Engineering Change Notification

This notice is to inform you of a change to the following Serial LCD product(s):

NHD-0216B3Z-FL-GBW-V3
NHD-0216B3Z-FL-GBW-V3-RC

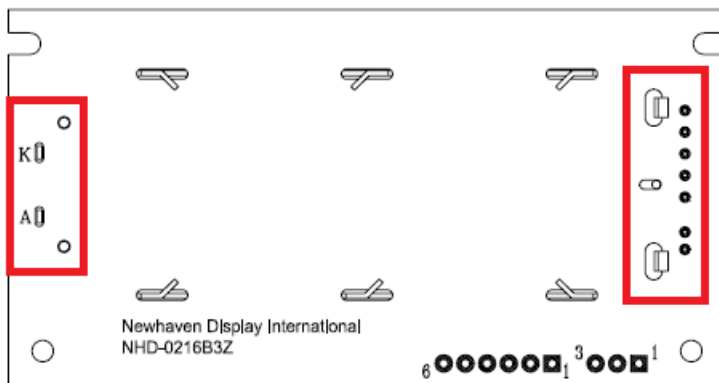
The backlight module on these displays has been redesigned to include new latches and alignment tabs for improved attachment of the backlight onto the display PCB.

This design improvement should not have any effect on the form, fit or functionality of the display in your application. We understand each project is unique and therefore recommend you review the updated datasheet and evaluate new samples for validation.
